**OVERVIEW**

AREA 1 | WEST MERCER WAY TRAIL CROSSING

## AREA 2 | TRAIL CONNECTION UNDER THE 72<sup>ND</sup> AVE SE OVERPASS

**AREA 3 | RESTROOM FACILITIES NEAR FERGOLIA PLAYFIELDS**

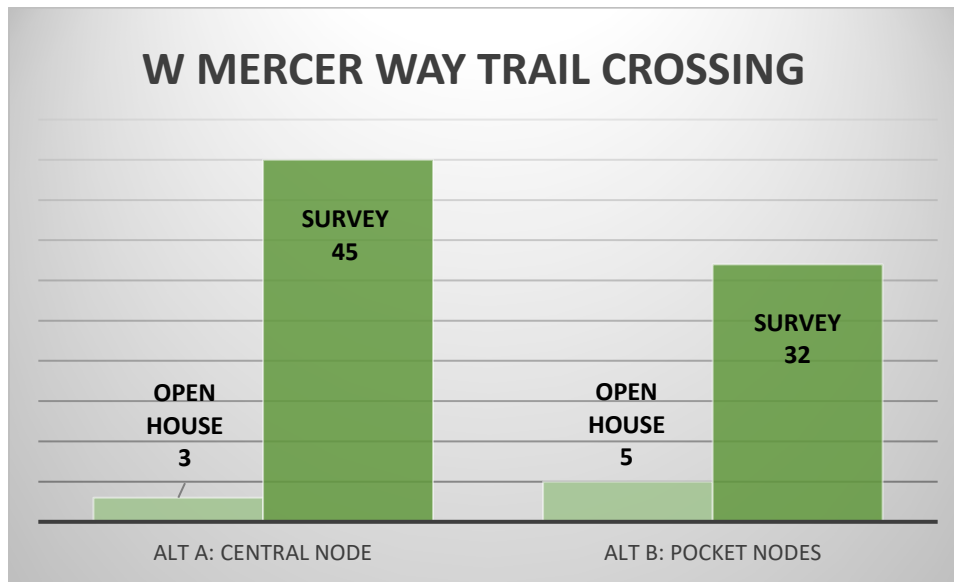
- *“The nodes are intended to give riders a resting area and access to bike amenities (pump/bike rack). At present, some cyclists gather in that area to regroup or meet up with other riders before circling the island and the nodes would enhance that option.” (LT)*
- *“Remove sidewalk along back of curb. That sidewalk is not used by cyclists (in my experience) and I don’t believe cyclists would miss it. Pedestrians may use it when walking down to the bottom of the hill.” (LT)*
- *“I’m ambivalent about the “nodes”, constructing a kiosk is a good idea. If we had a kiosk there (or near the restrooms as is also an option) the city could post cycling maps and the Island’s “Rules of the Road” document.” (LT)*

- *Why can't we do both [alternatives] A and B? (Open House)*
  - *Design Team responded that the number of alternatives chosen are dependent on budget. The project team is looking for feedback on desired conceptual preferences which will help inform how many improvements can be made.*

#### Area 1: Alternative A | Central Node

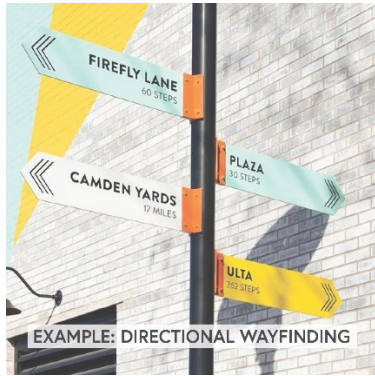
- *“Having a node closer to the streetside would allow for better access for maintenance and can provide more visibility from the road (have more eyes on it).” (City staff)*
- *“I also don't get the kiosk. Three nodes and a kiosk start to look like park clutter to me.” (LT)*
- *“I like Alternative A—one [central] node is less busy and the location I think works better for way finding and encouraging the use of the alternative route on West Mercer Way that goes around the park.” (Open House)*
- *“Seems best for how I see people use that area.” (Open House)*

Area 2: Alternative A | Circulation Mindset

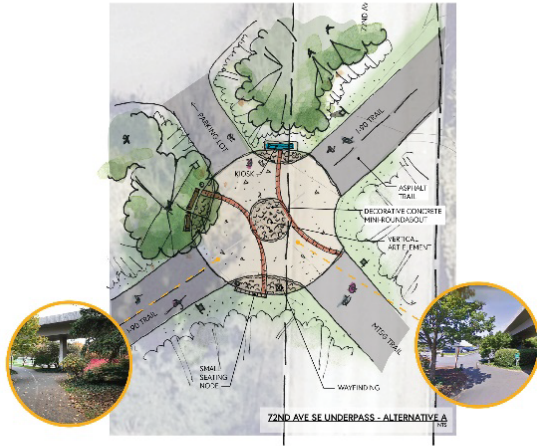
- *“I’m a fan of the roundabout option, even if it’s not raised, it could still signal people to pay attention to who has the right of way.” (City staff)*
- *“I like the roundabout. Strollers and dogs tend to wander across the path, and this is the worst sightline area, in my opinion. If installed though, there would have to be some very strong pavement paint to encourage turning short.” (Open House)*
- *“...We want to slow bicyclists...The roundabout has to be designed to allow a bicyclist who did not slow enough earlier to recover...” (LT)*

Area 2: Alternative B | Realigned Mindset

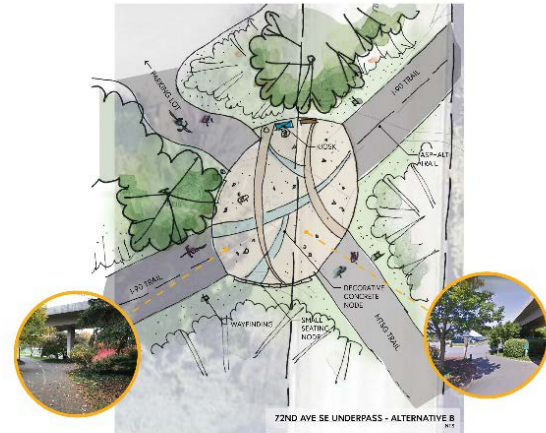
- *“...while roundabouts are often used on streets (and cyclists are familiar with them), they are hardly ever used on trails.... don’t know where pedestrians are supposed to be on the roundabout.” (LT)*
- *“This node should continue to have the striping that separates the sides of the trail, but otherwise this option is fine.” (LT)*
- *“I like Alternative B because it realigns the trail from the parking lot and improves sight lines. That could be accommodated in Alternate A, couldn’t it?” (Open House)*

### Public Comments on General Design for Area 2

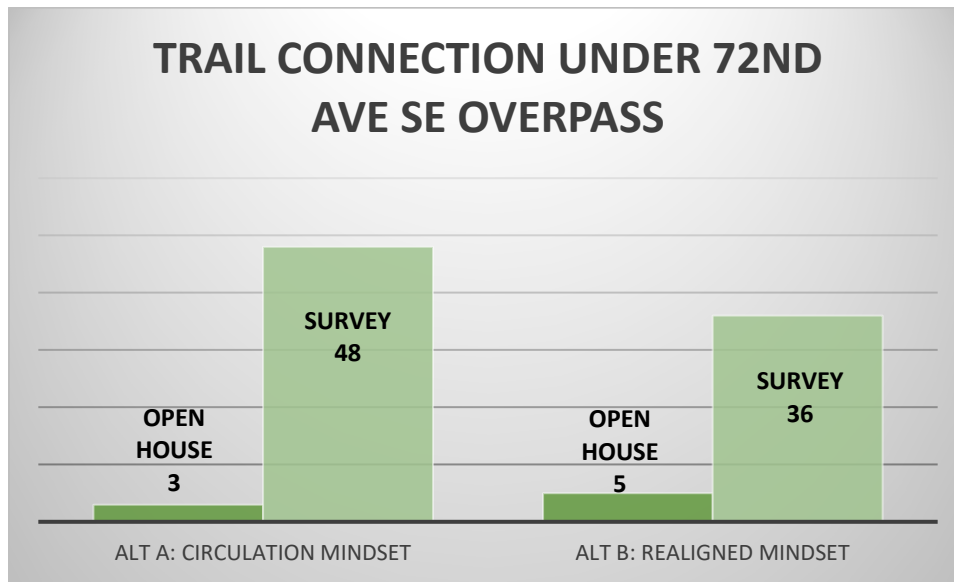
- Reduce impervious surface area as well as reduce traffic to this mixing zone by providing better access and provide better connection to ballfield area on the north. (Design Team)
- *"I do think some traffic calming measure will be necessary at the backstop which is the "Y" for both trails going to the town center. If bicycles are slowed at this juncture, I don't think they can create more speed by the bathroom."* (LT)
- *"Or why would you run the path from the parking lot to the roundabout? This is the one area we want to separate slowing bikes and pedestrians, not mix them... And eliminate the current path from the parking lot to where the roundabout will be located, and as noted below route those pedestrians to a marked crossing closer to the bathroom where bike speeds will have slowed."* (LT)

**Public Comments on General Design for Area 3**

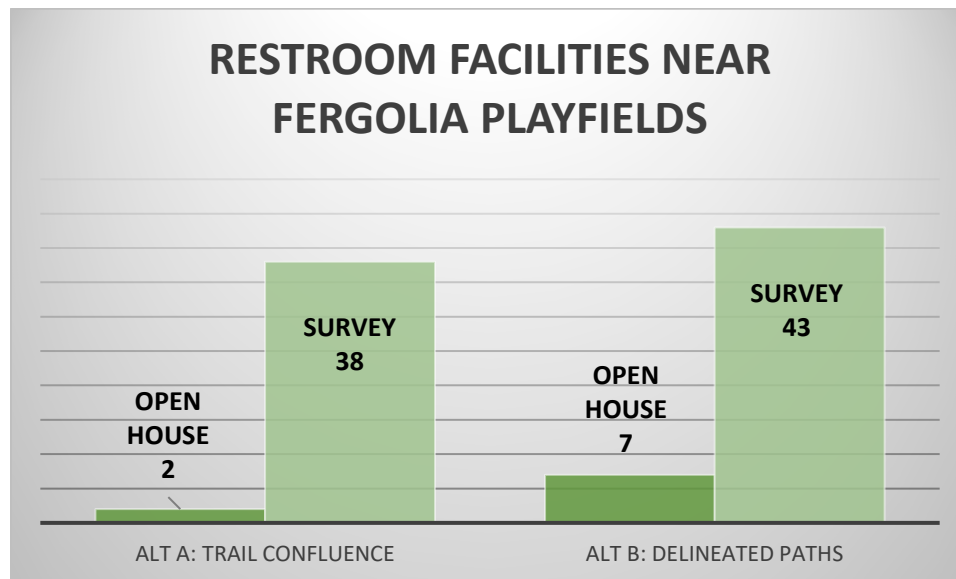
- Awareness goes both ways for all users (bikers, walkers, strollers, etc.) (Design Team)
  - *“All users could benefit everyone by being more self-aware of how their actions affect others.” (LT)*

- *“You want them (users) to walk along the grass part of the field to cross closer to the bathroom in a central marked crossing where bike speeds are low, not near the roundabout.” (LT)*

- *“These would funnel pedestrians (and dogs) from the parking lot to a central main crossing in the trail after the roundabout, so bike speeds are slow and this part of the trail crossing is marked. Another (low) ranch style fence along the grass next to the field would funnel pedestrians wanting to use the bathroom or cross the trail away from the roundabout and towards the marked crossing.” (LT)*

- *“In several places the plan calls for ‘informal fencing’ to control where pedestrians can cross the trail. This is an effective, low-tech way, of giving users of the trail predictability as to where pedestrians will cross. That is a good option. I would additionally add raised cross walk markings on the trail in those locations.” (LT)*

- *“I don't like the plan to expand the gathering area with impervious surfaces that extend into the grass field.” (LT)*

- There are fewer numbers of mixing zones (compared to Alt B) and minimized points of conflict. (Design Team)
- Alt A is more straightforward and will require less signage than Alt B – providing less park clutter. (Design Team)

- Alt A has no separated landscape buffer and will require less maintenance than Alt B. (Design Team)
- *“Why would a pedestrian cross a paved path from the dugout to reach another path when they can just walk on the main path and have legal priority?” (LT)*

- *“If you need to meet the letter of the law, make a 12' trail through the plaza and then give it a 6' apron. Or call it a plaza. Trail, asphalt. Plaza, concrete. Two different things...The separate trail just means you'll have pedestrians on both trails.” (LT)*

- *“It REQUIRES anyone on the field wanting to use the bathroom to cross the trail to get to the walking trail at all different points, exactly what you don't want to do.” (LT)*

- People who preferred option B liked it because it provided more space and ultimately the public had a perceived notion that the separated pedestrian and bike paths provide more space. (Design Team)
- *“In constrained areas where widening a single trail is not practical, the multi-use pathway separates into two trails so walkers and bikes can still be separated.” (LT)*
